Report to: Development Services Committee

Report Date: December 6, 2011

SUBJECT: RECOMMENDATION REPORT
Application by King Square Limited for Site Plan Approval to permit Phase 1 retail and commercial development at 9390 Woodbine Avenue
File SC 06 109164

PREPARED BY: Ron Blake, Development Manager, West District

Proposed Site Plan – Phase I

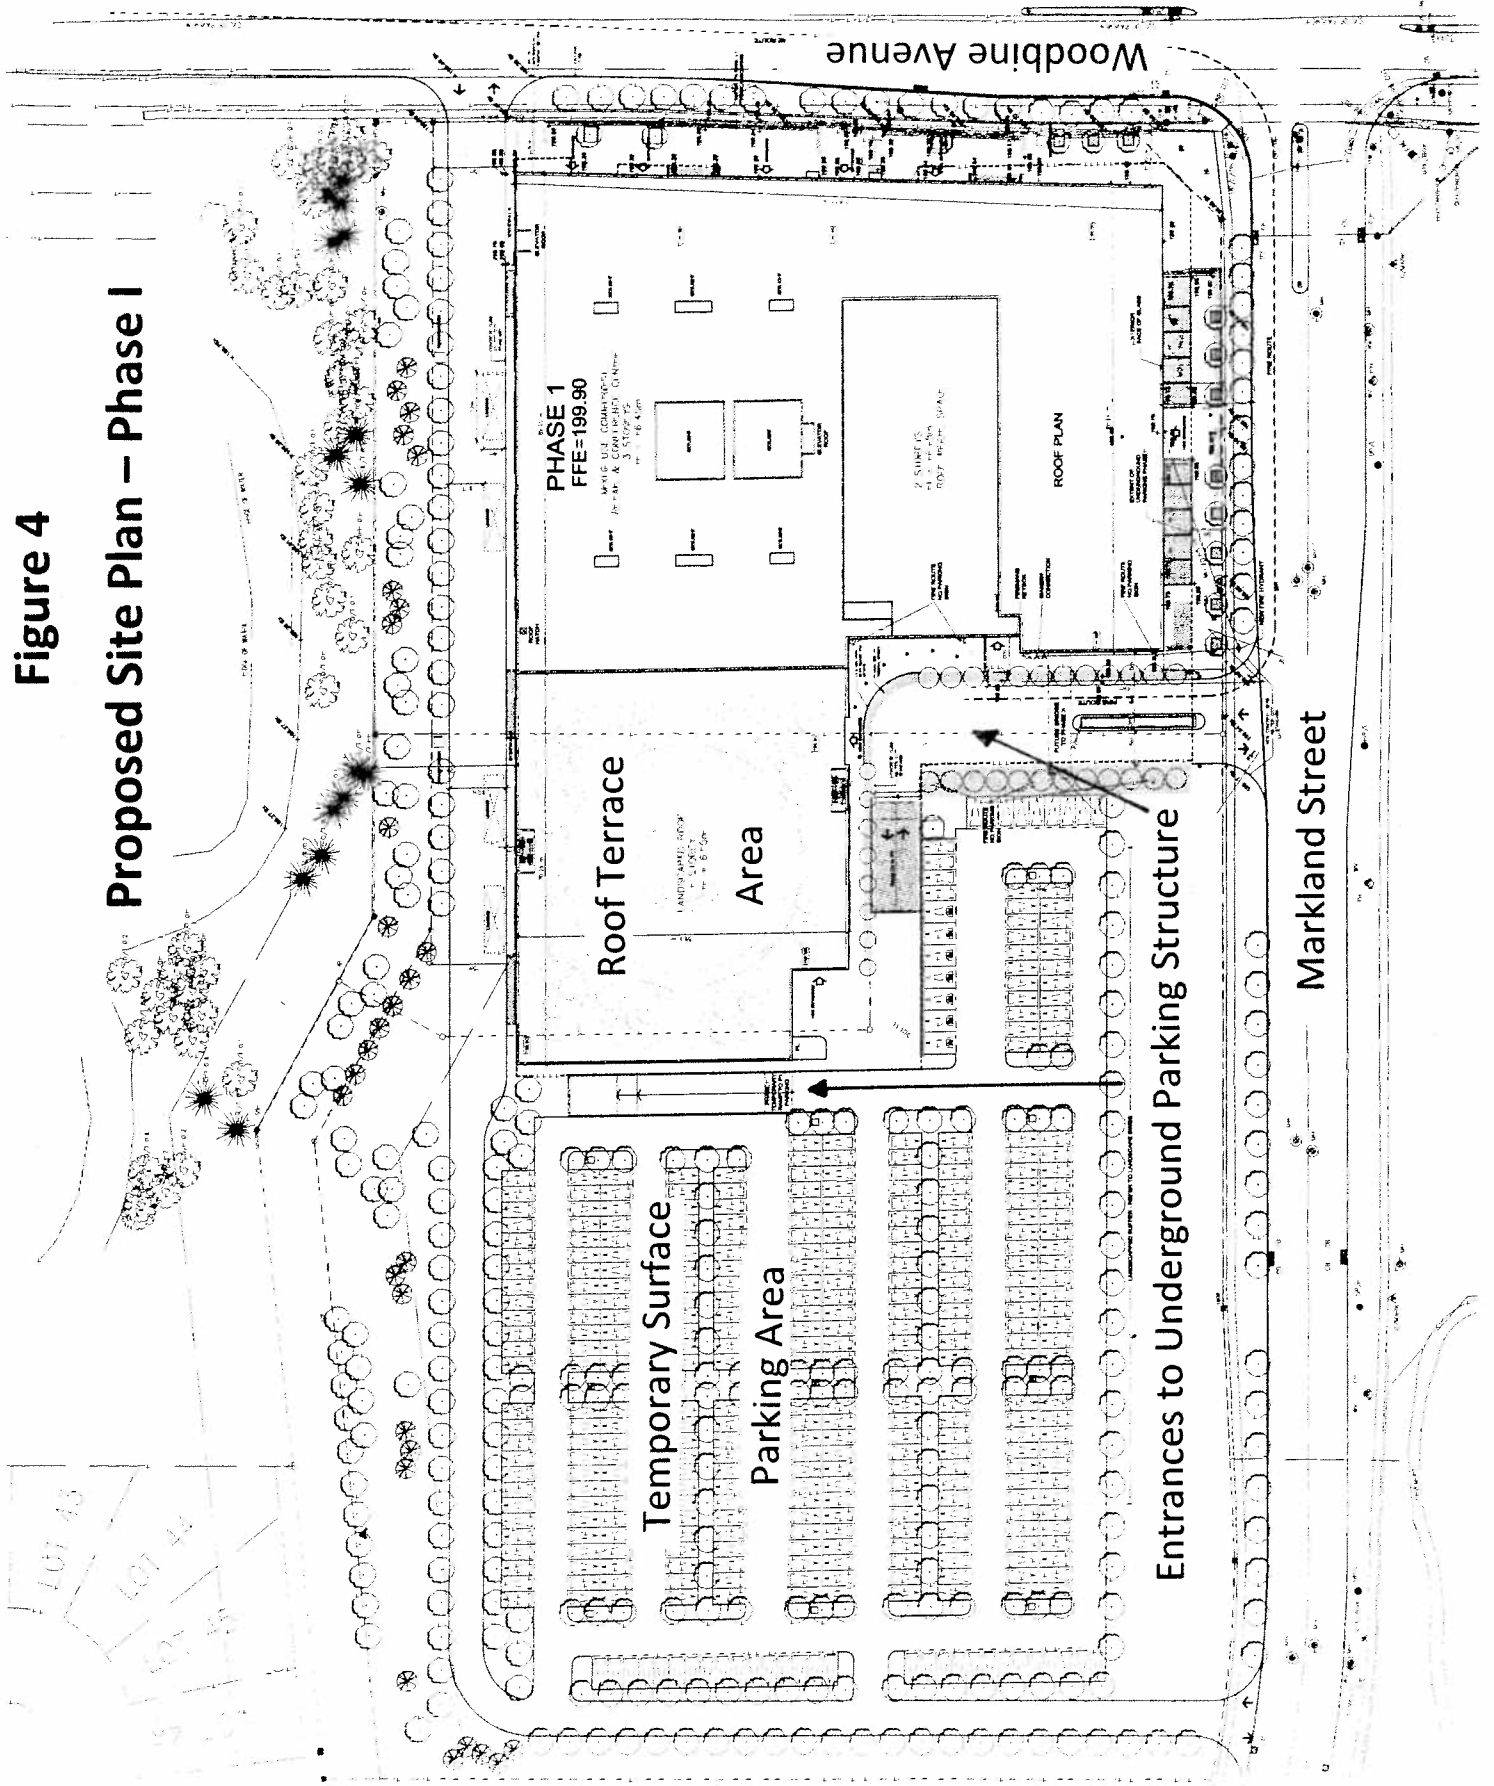
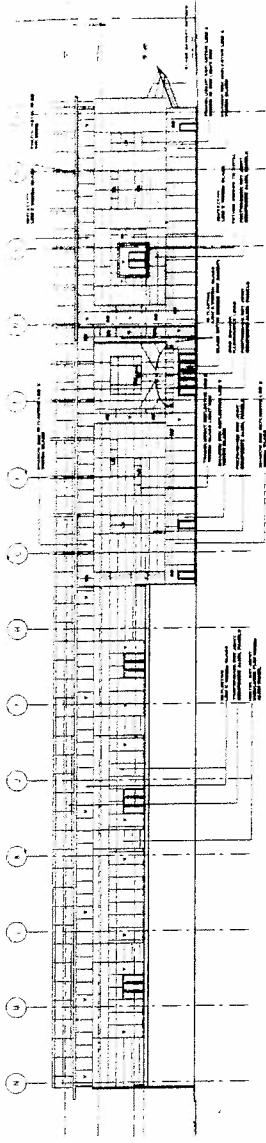
The proposed development consists of a large, two and three-storey commercial building on the eastern half of the site, with street-wall frontage along Woodbine Avenue and Markland Street (see Figure 4). Parking will be provided partly in a 2-level underground garage and partly on a temporary surface parking lot located on the western half of the site (with frontage on Markland Street). The primary car access to the underground parking will be from a driveway located mid-way along the Markland Street frontage, which will also provide access to a passenger drop-off area inside the underground parking garage. A second temporary access ramp to the underground garage will be located in the surface parking area. During Phases 2 and 3, the surface parking area (including the temporary access ramp) will be redeveloped with several hotel buildings (fronting Markland Street) and additional retail space to the north. The underground garage will be extended westward below the new development. Truck loading and waste management areas will be consolidated along the northern frontage of the building, with

- Relocation of the passenger drop-off area from the Markland frontage to a location within the underground garage (agreed to by applicant);
- Provision of five, grade-related pedestrian entrances along the Woodbine Avenue frontage that correspond to the internal arrangement of corridors in the retail mall (agreed to by applicant) and corresponding revisions to the Woodbine elevations to emphasize these entrances;

- The finished ground floor elevation may be maintained at 199.9 m (with the finished ground floor elevation of the bank at the southeast corner of the property to be set at 199.0 m) as shown in the November 17, 2011 revised site plan, provided that the following conditions are met:

- The slope from the existing sidewalk on Woodbine Avenue to the edge of the building (including to the finished floor elevation at the Woodbine entrances to the building) will not exceed 2%.

- All differences in elevation between the Woodbine Avenue sidewalk grades and the interior finished ground floor elevations will be accommodated through interior steps;

- The finished floor elevations along Markland Street will not exceed a 5% slope to existing sidewalk elevations, with a 1.5 m clearance area on either side of the entrance doors having a minimal slope in accordance with accessibility guidelines;

-
- All exterior steps or walls along the Woodbine Avenue and Markland Street elevations are to be removed from the site plan. Exterior changes in grades between the building frontages and the existing sidewalks are to be accommodated through at-grade slopes.

- The Town's Engineering Department has advised that the site servicing and grading plan will need to be revised to accommodate the above referenced changes in elevation. In addition, the Engineering Department also advised that based on information from the soil investigation, the natural groundwater level will be affected by the anticipated new elevation at the base of the underground parking garage floor. The Owner will need to address this issue to mitigate any impact to the groundwater level prior to Site Plan Endorsement.

- Staff will continue to work with the applicant to explore opportunities to resolve these matters including finalization of the geotechnical analysis undertaken to date. Satisfactory revisions to the site plan, grading plan and conceptual elevations will be required prior to staff endorsement of the site plan.

The conditions of site plan approval, set out in Appendix 'A' require that a revised site plan, addressing the above matters to the Town's satisfaction, be submitted prior to site plan endorsement.

Figure 5 – Proposed Elevations

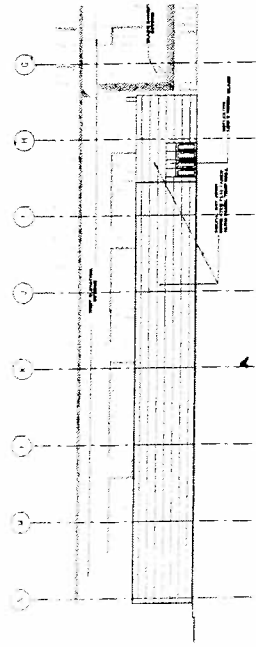
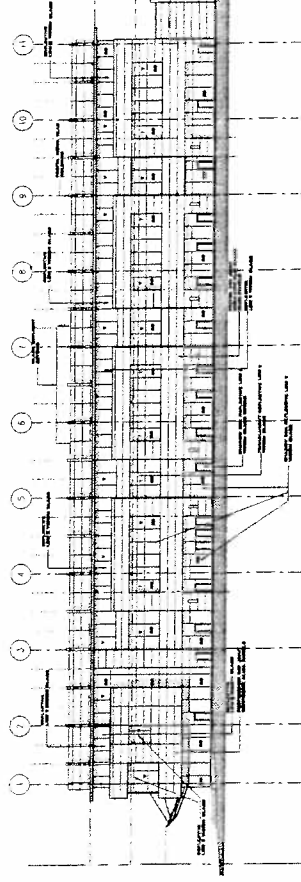
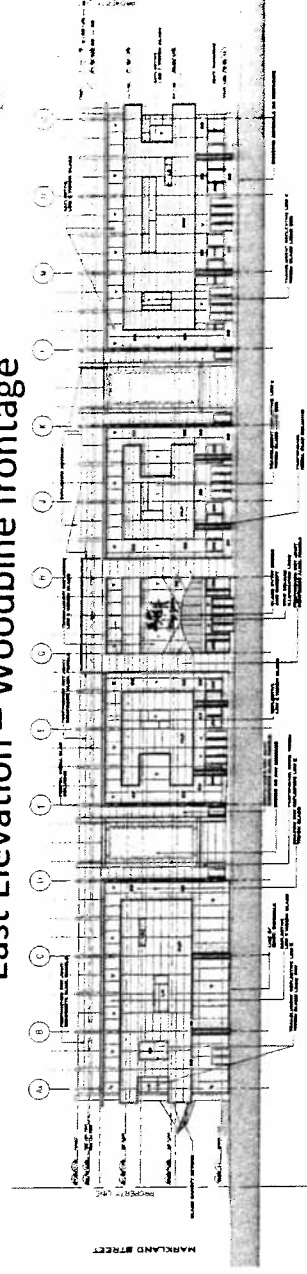
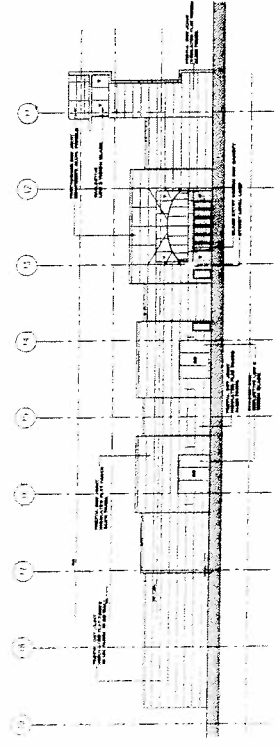
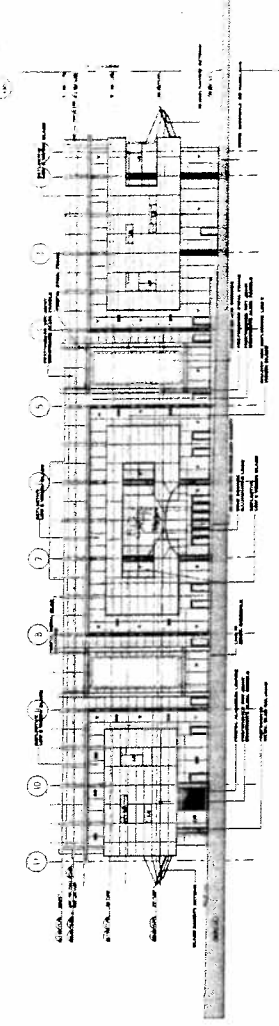
Grading, landscape treatments, building materials, and other design elements that: enhance at-grade pedestrian permeability into the structure; break up the massing of the building on the upper stories, particularly across the long Woodbine Avenue frontage; and lighten the visual impact of the structure, will play a key role in the successful design of this development. Staff have been working closely with the applicant to refine several key design elements that will promote these objectives, including the following refinements to site plan:

As well, staff continue to work with the applicant to incorporate a variety of design elements including window details, entry treatments, the use of colour-contrasting materials, and enhanced vertical detailing, to reduce the visual massing of the building along the Woodbine Avenue and Markland Street facades. The conditions of site plan approval attached as Appendix 'A' require that the refinement of endorsed elevations be submitted to the Town's satisfaction, prior to site plan approval.
